22 August 2019

218990

**RE: SSD 9670 Response to Submissions  
Western Sydney University Innovation Hub, 2-6 Hassall Street, Parramatta**

**Figure 1 Proposed rear decking / breakout space**

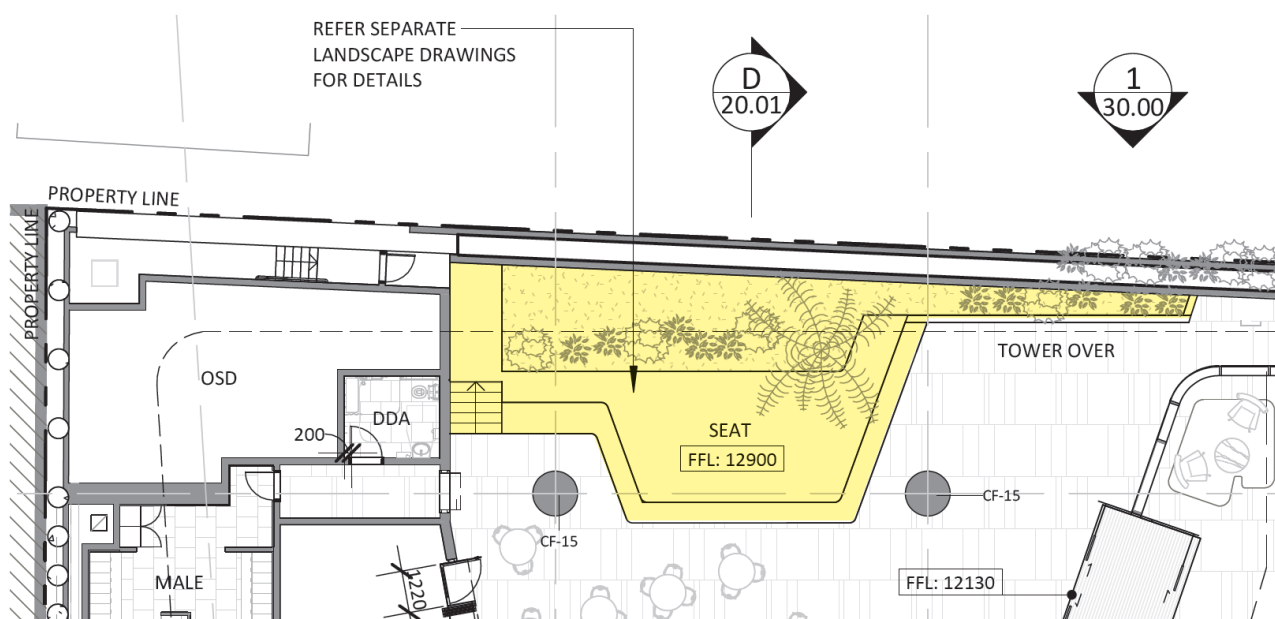
Council has requested that further information be provided on how the potential future through site link to the Lancer Barracks could work, with design options and levels to be provided.

The design as lodged at the Lancer Barracks interface included a landscaped area providing a transition to the Lancer Barracks boundary. Fronting this landscaped area, was a set of angled stairs which would serve as a breakout space for students and office workers utilising the plaza and retail areas, designed to be easily adapted in the event that the Lancer Barracks is released as public open space in the future.

In order to provide further flexibility, the design of these northern stairs / breakout space has been further refined, as described in **Section 2.0**, and shown in **Figure 1**. The design allows adaptation for a DDA compliant ramp traversing both the subject site and the Lancer Barracks, as shown in **Figure 2**. This option retains and integrates

the proposed stairs with the DDA design, retains the proposed timber decking, and retains the potential for mass planting and feature trees between ramps.
